## Change Order, Construction Manager as Adviser Edition

<b>PROJECT:</b> <i>(name and address)</i> Central Hardin High School Addn/Renov  Ceclia, KY	<b>CONTRACT INFORMATION:</b> Contract For: BP 092-05 Gypsum Board Assemblies Date: July 14, 2021	<b>CHANGE ORDER INFORMATION:</b> Change Order Number: 100  Date: February 8, 2024
<b>OWNER:</b> <i>(name and address)</i> Hardin County Board of Education 65 W A Jenkins Road Elizabethtown, KY 42701	<b>ARCHITECT:</b> <i>(name and address)</i> JRA Architects 3225 Summit Square Place, Suite 200 Lexington, KY 40509	<b>CONSTRUCTION MANAGER:</b> <i>(name and address)</i> Alliance Corporation 116 E. College Street Glasgow, KY 42141
<b>CONTRACTOR:</b> <i>(name and address)</i> Bennett's Contracting, Inc. 109 Steve Drive Russell Springs, KY 42642

Cost associated with adding chase walls and soffit per RFI 128 response.

SUBJECT: Area B Chase RFI ID: 00128

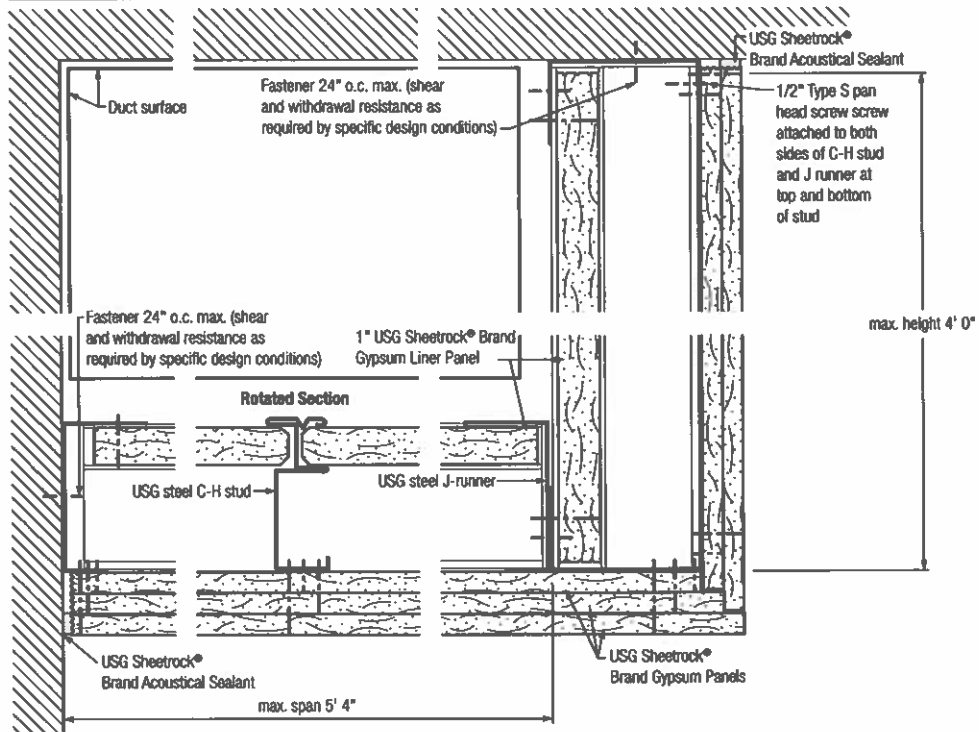
QUESTION: The chase in question that is located in Area B on the gym floor level appears too small to accept all of the ducts etc. There has been numerous discussions as to achieve the results needed to accommodate all of the material required to fill this chase. Please provide the answer that best works.

ANSWER: Refer to attached sketch for modified duct routing at chase in Lower Level Area B (sheet M110B). The plan north supply ductwork shall reduce in size to 12x16 and shall route plan north to exit chase. The plan south supply duct shall route plan south to exit chase. 1" R-6 ductwork insulation shall be permitted within chase where spacing requires. Provide rated shaft-wall ceiling assembly and fire dampers to close off chase at the First and Second floor Levels. Provide a loose lintel over new opening in masonry wall for ductwork per schedule on sheet S-101. Where the duct exits the chase to the south into the stair enclosure, cover the duct with shaft-wall assembly to walls and deck above to maintain fire rating of stair enclosure. The existing opening on the east side of the chase on the Lower Level can remain open (not filled with CMU) since it does not provide a fire rating and the outer chase wall closes off the opening. Locate the access panel in the outer chase for maintenance of the fire dampers located at the First Floor Level. Locate access panels above the First Level ceiling for access to the fire dampers in the chase at the Second Floor Level.

In rooms B117 & B223, core drill holes for the 2 roof drains and sanitary as required. Openings cut in the field will have to be coordinated with the precast supplier. Close off in Metal stud/gyp chase to 8" above ceiling as shown on sketch. Move the Teacher Wardrobe as needed.
